# PERMIT

SEWAGE DISPOSAL SYSTEM

ROAD Route 108 - last house on lot  
left before you get to Manor Lane

PROPERTY OWNER Mr. Gardiner

INDICATE NORTH. - NAME ADJOINING ROADWAY AS BASE LINE.

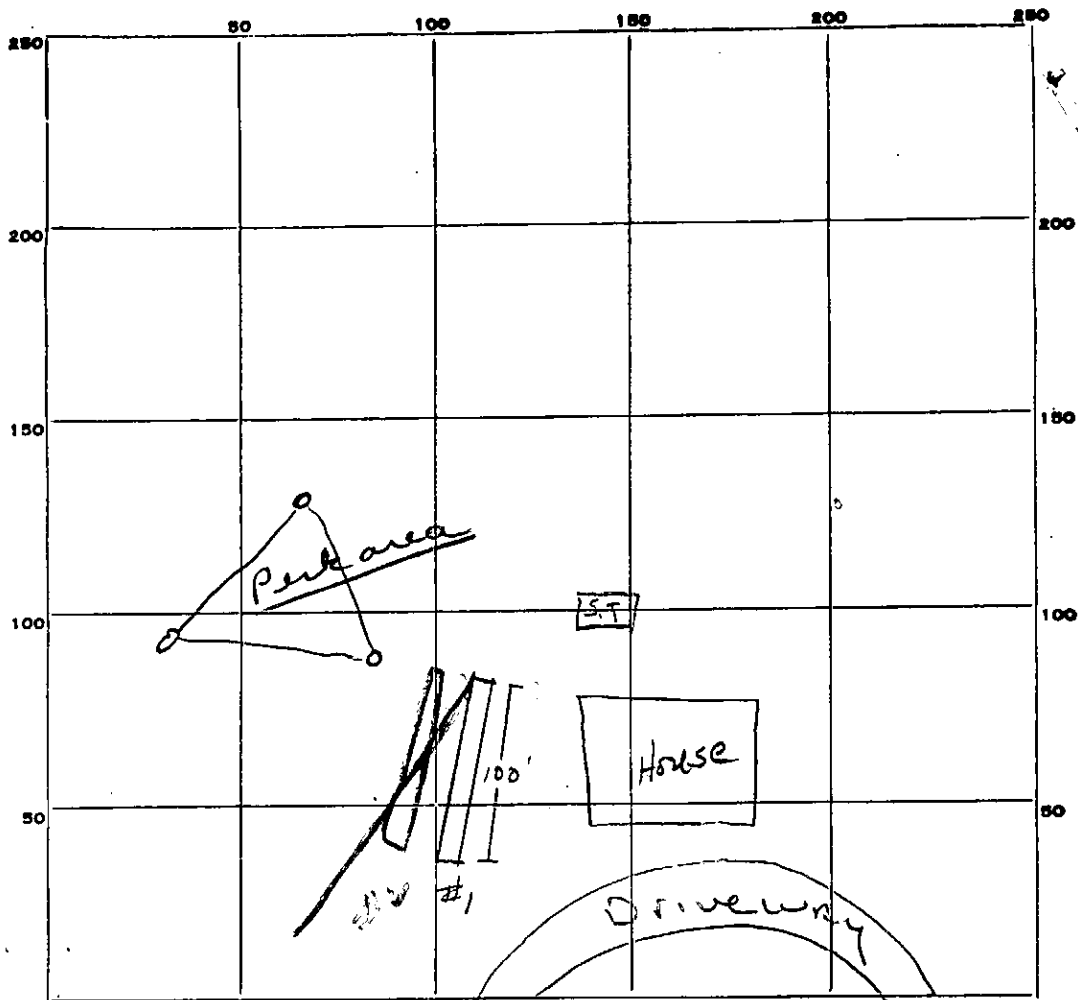
*Not*  
OTHER TRENCHES - Two trenches, each trench 100 ft. long, for a total absorbent area of 800 sq. ft. Inlet can come in at 4 ft. and maximum depth permitted is 8 ft. Trenches to run from back to front across left side yard as close to house (around 20 ft.) as possible. Okay to tie into terra cotta pipe 20 ft. from house. NOTE: Switch in distribution box only. NOTE: NEW LINE FROM WELL TO HOUSE TO BE INSTALLED.

*OK to start trenches 10-12' deep - but keep as shallow as possible to keep 4' stone upon 1/6/76*

REMARKS Trench #1 10 1/2 deep - invert will be at 6 1/2'  
100' long - HIB - ok to place stone into Trench #1,  
Trench not close to house invert @ 6 not 4, only 1  
trench, bid for more info. PAB

OK to cover 1 trench, start another PAB Mar 77  
#2 6'-10' 100' long, MAR 18 1977 - ok to add stone to trench  
#2 - HIB

INDICATE NORTH. - NAME ADJOINING ROADWAY AS BASE LINE.

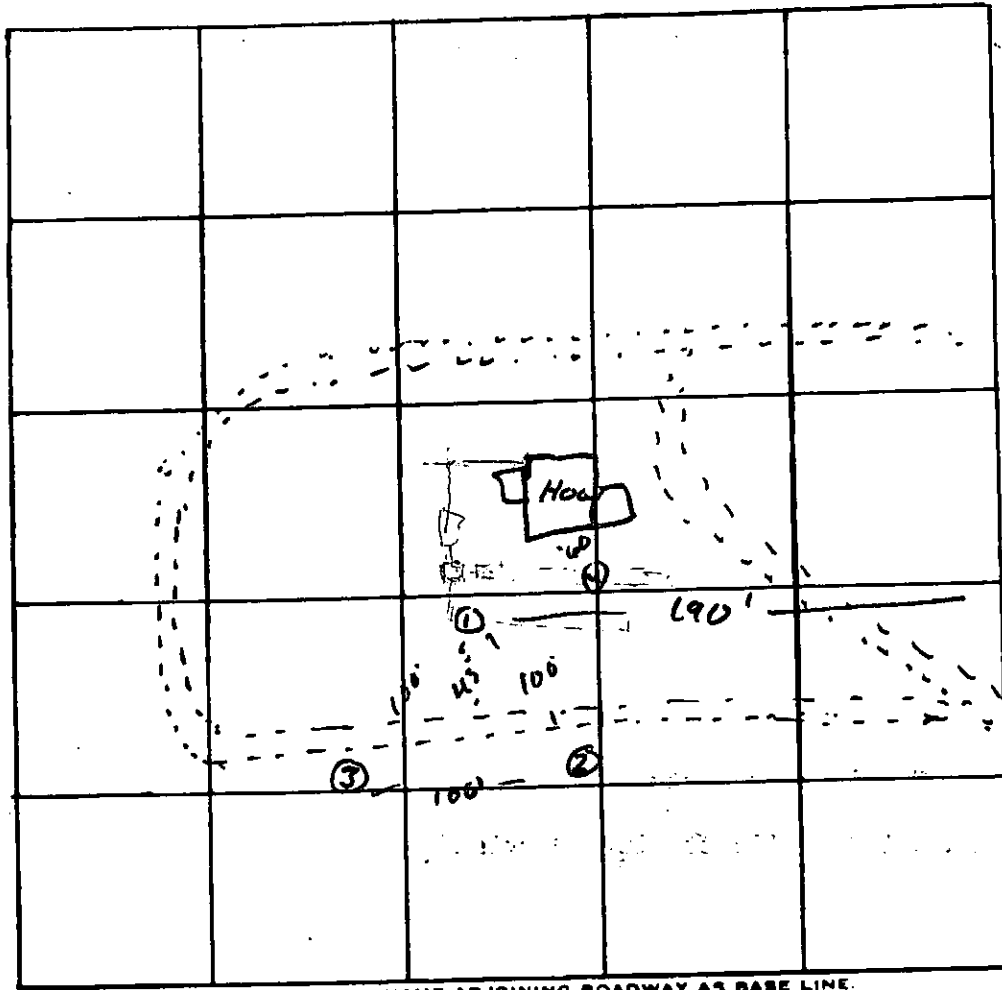
DATE	TEST NO.	DEPTH	PRE-WET		TEST - 1" DROP		TIME
			START	STOP	START	STOP	
11/19/44	1c	3'6"	12 45	12 00	12 00	12 35	35
	1d	13'	11 46	12 26	12 26	12 54	28
	2s	3 1/2'	12 06				
	d	11'	water				
	3s	5'	soil	begins to look good			
		10'	water				
	4s	8 4'	1 00	1 10	1 10	1 19	9
